RE: REVISED DRAINAGE PLAN FOR MANZANO ANIMAL CLINIC
(J-21/D31) REVISION DATED JULY 23, 1990

GRADING AND DRAINAGE PLAN MANZANO ANIMAL CLINIC

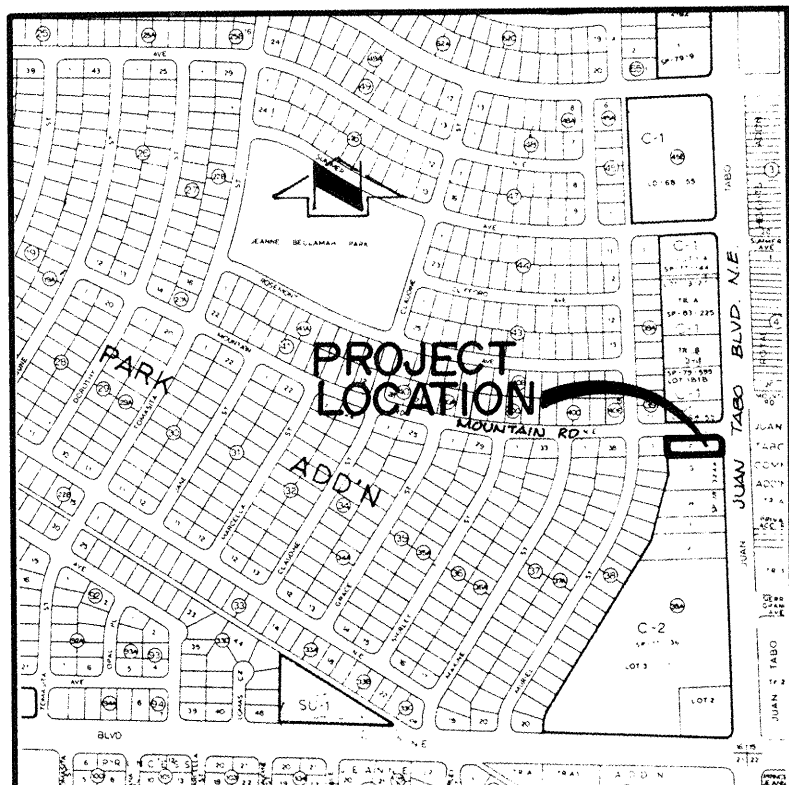
Based on the information provided on your resubmittal of July 24, 1990, revisions as indicated are acceptable.

If the building permit has already been issued, it is your responsibility to make sure that the contractor is given a copy of the revised plan.
